**BOULDER COUNTY
BOARD OF COUNTY COMMISSIONERS
PUBLIC HEARING**

SPR-23-0108: Piscopio-Huang Residential Remodel and New Accessory Structure

Staff recommends that the Board of County Commissioners uphold the Director’s Determination for SPR-23-0108, Piscopio-Huang Residential Remodel and New Accessory Structure.

1 Existing South Exterior Elevation
1/4" = 1'-0"

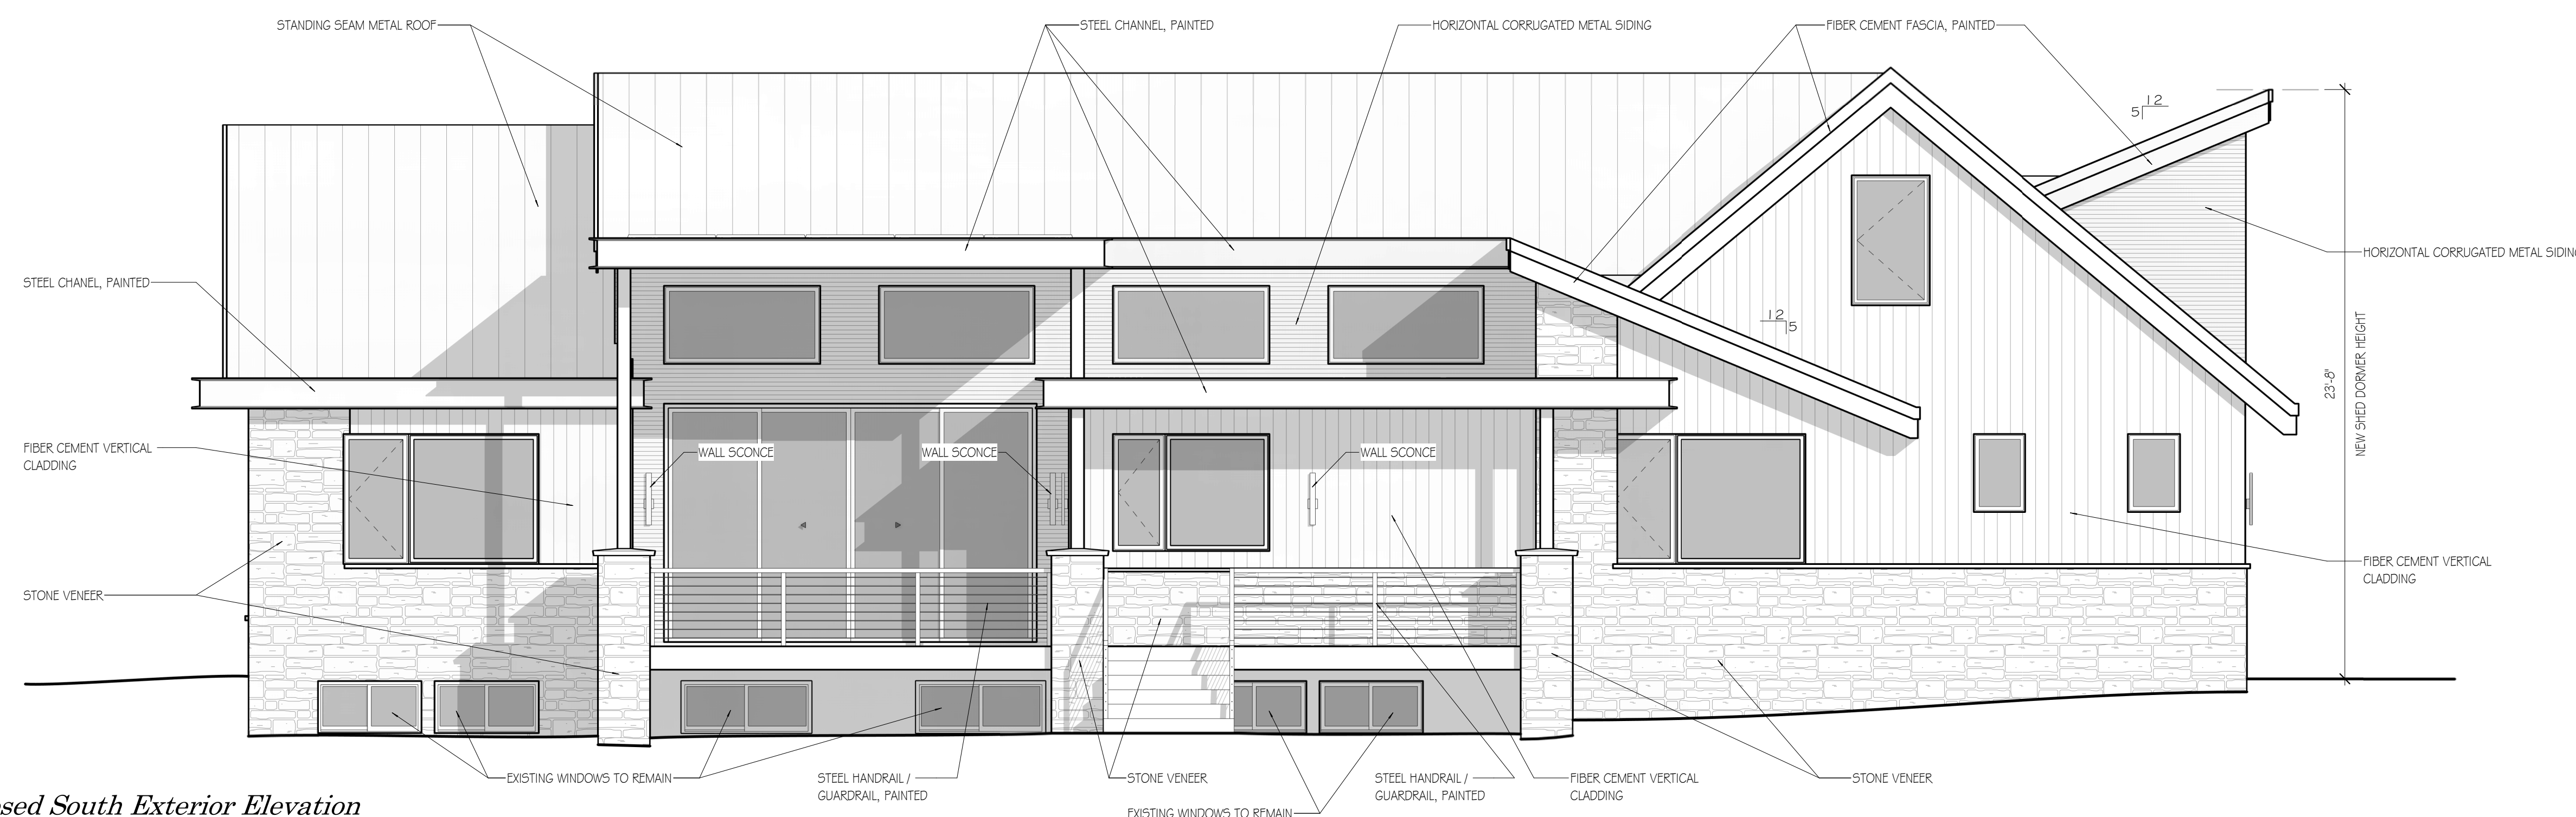
The submitted narrative dated November 13, 2023 that was included with application materials states that the existing basement will be converted to crawlspace. However, the elevations and floor plans dated November 13, 2023 include existing windows to remain on the south elevation at the basement level. To comply with the Building Code, windows are not permitted in a crawlspace.

At time of building permit, submit revised elevations reflecting removal of the basement level glazing on the south-facing façade for review and approval by Community Planning & Permitting Staff.
